ADDENDUM NO. 1

CITY OF ROLLA
TAXIWAY A RECONSTRUCTION AND TAXIWAY CONNECTOR REHABILITATION
at
ROLLA NATIONAL AIRPORT (VIH)
VICHY, MO

MoDOT Project # 23-056A-1

ADDENDUM NO. 1

TAXIWAY A PLAN AND PROFILE
STA. 13+00 - STA.19+50

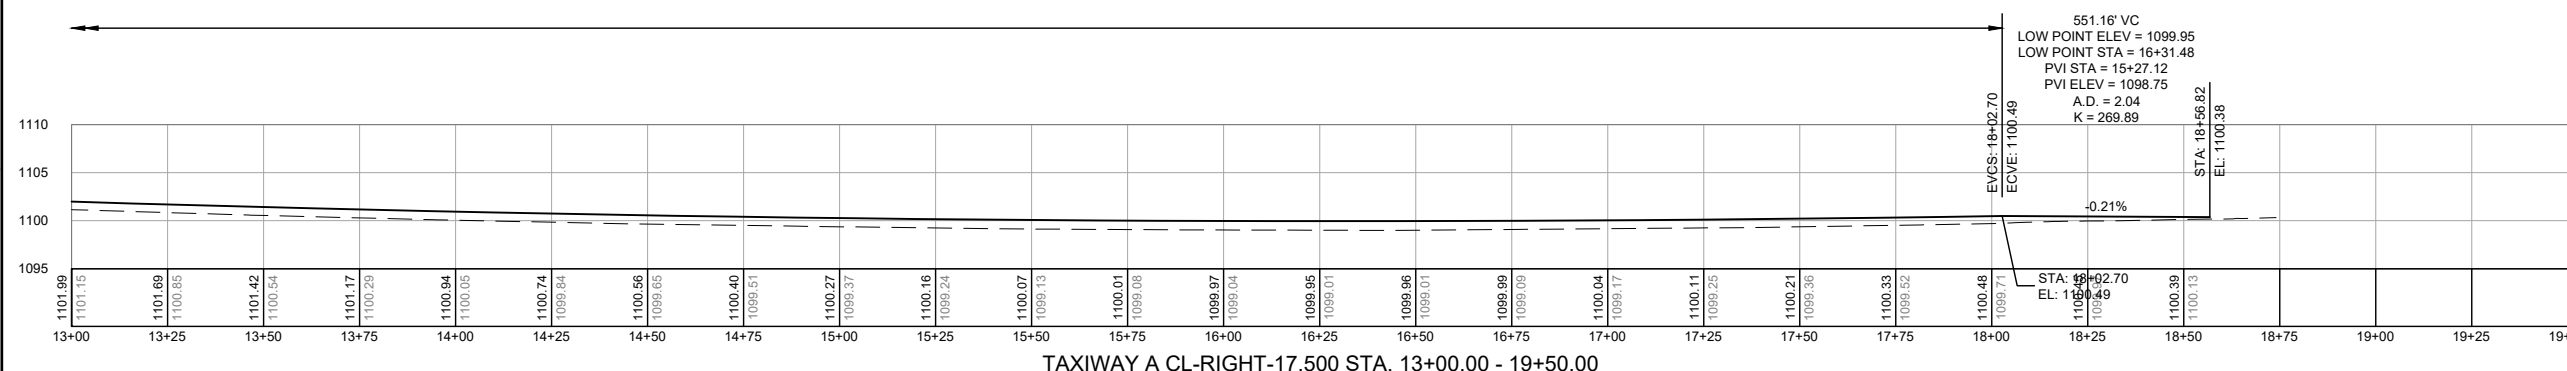
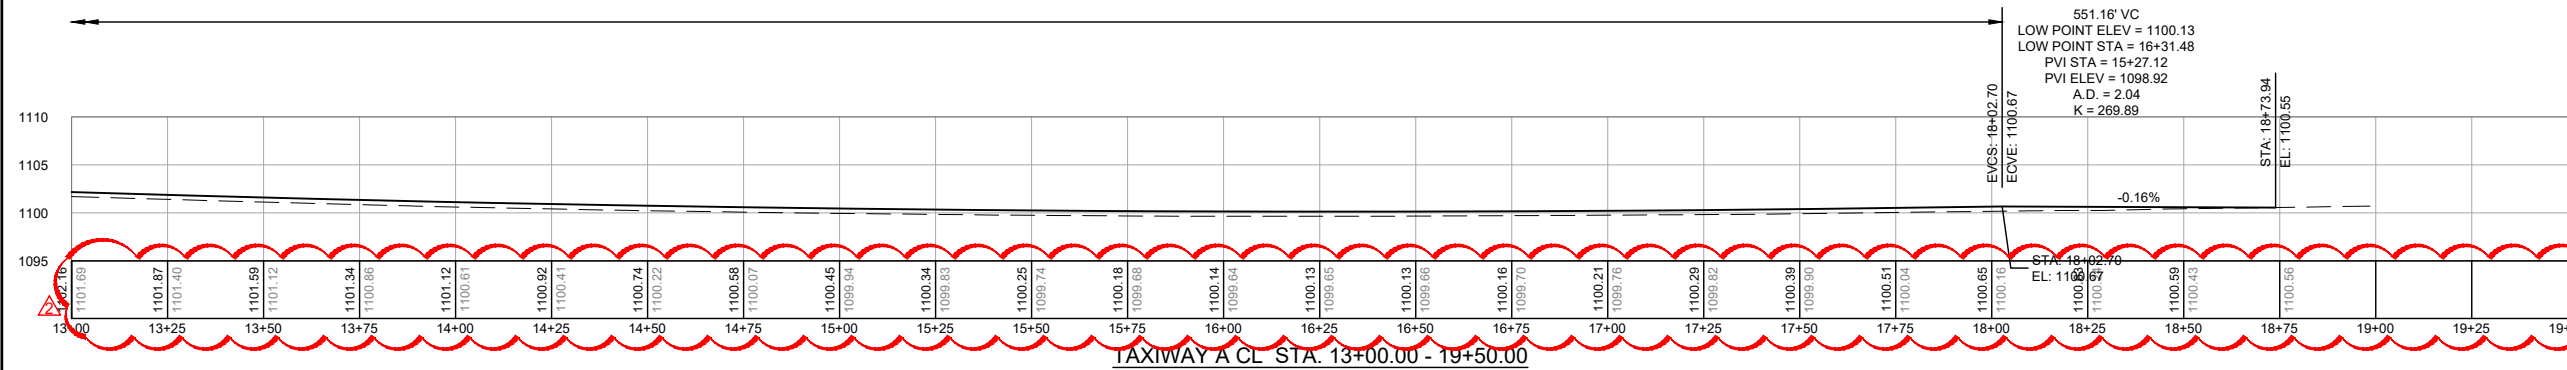
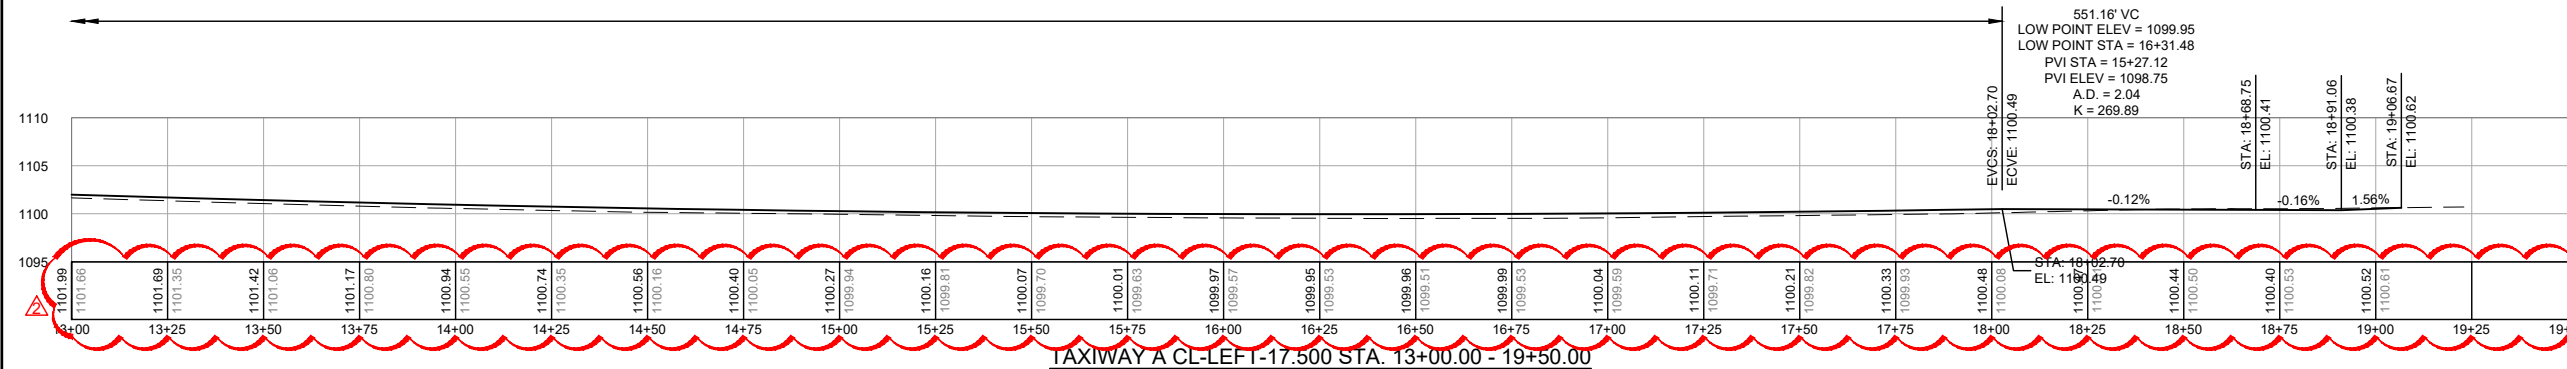
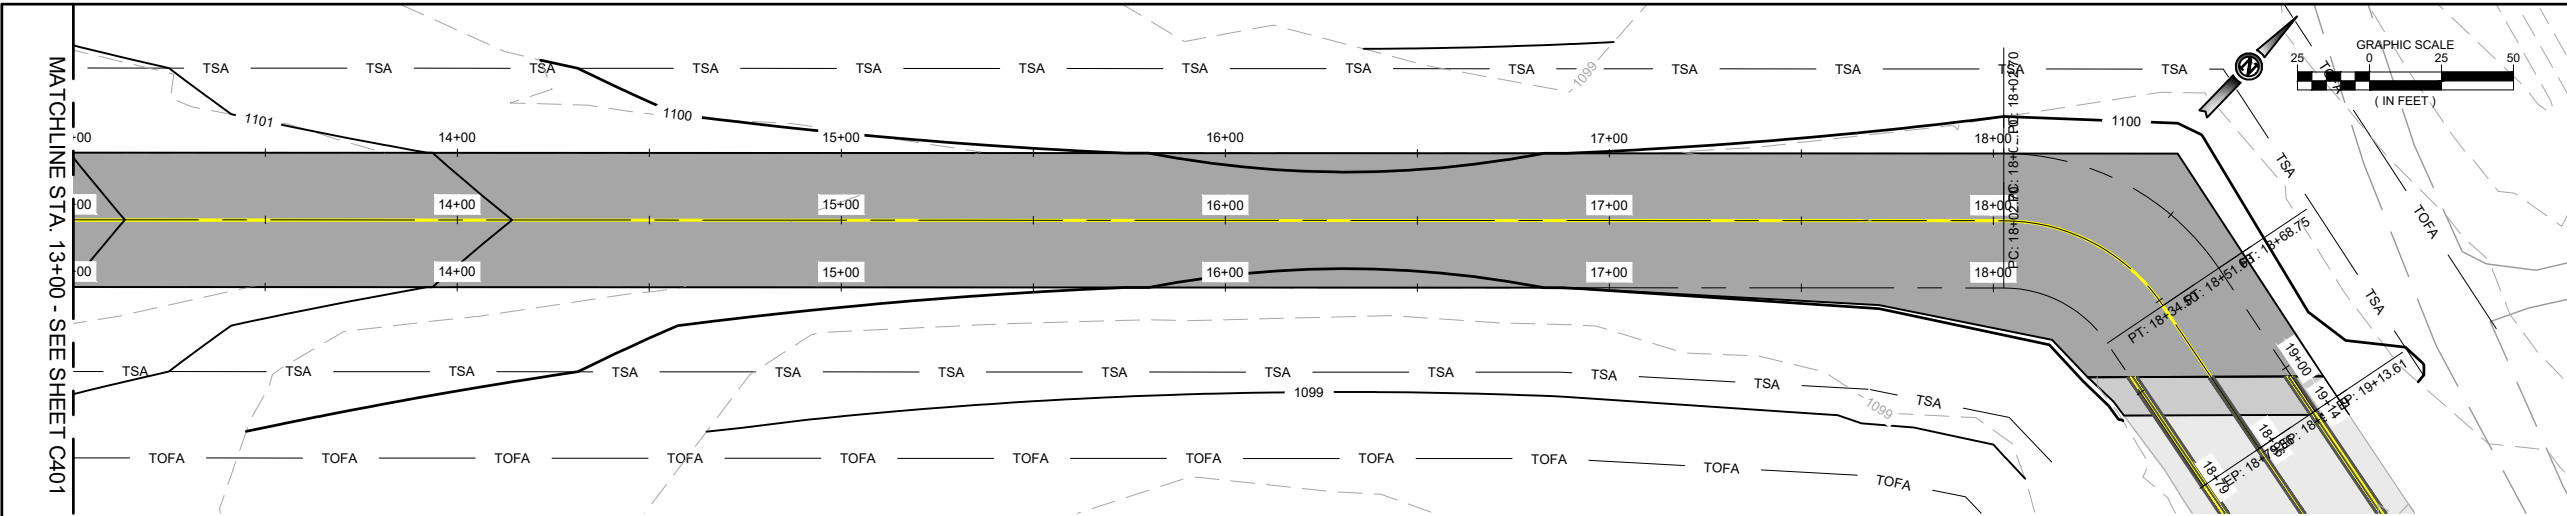
Revision: Added existing and proposed grade labels to profile stationing.

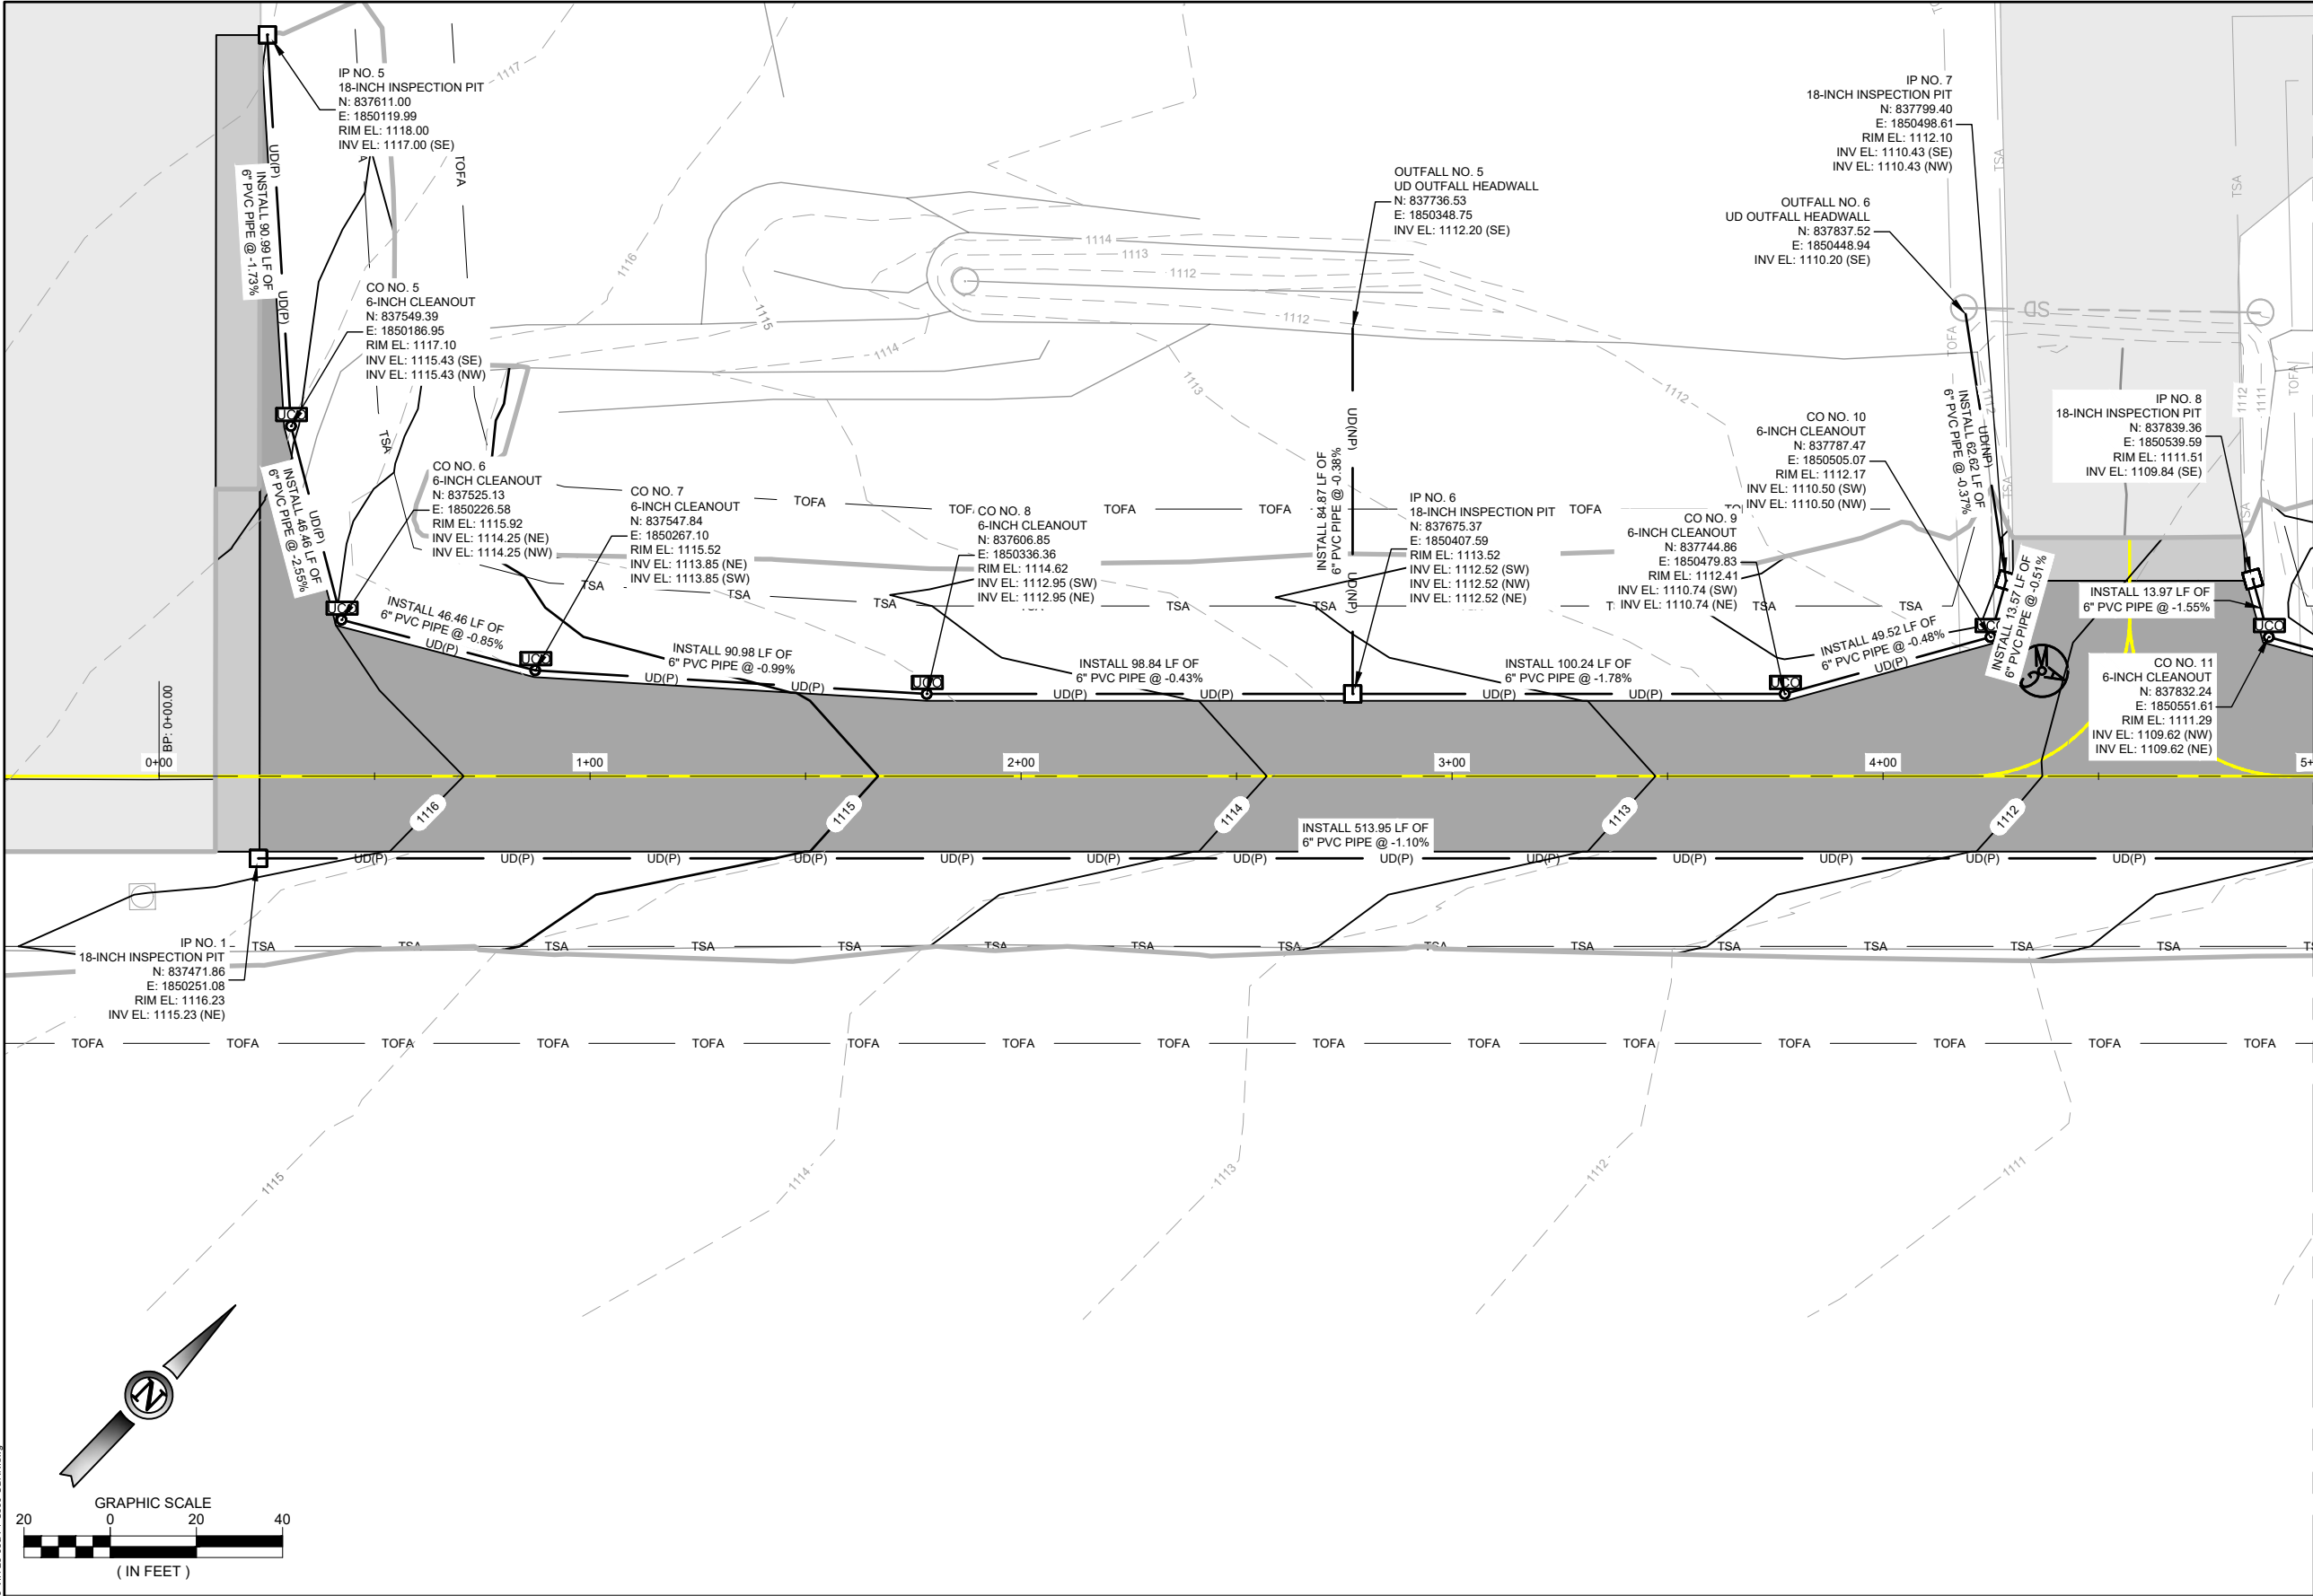
Revision: Added outfall to previous inspection pit, IP NO. 4.
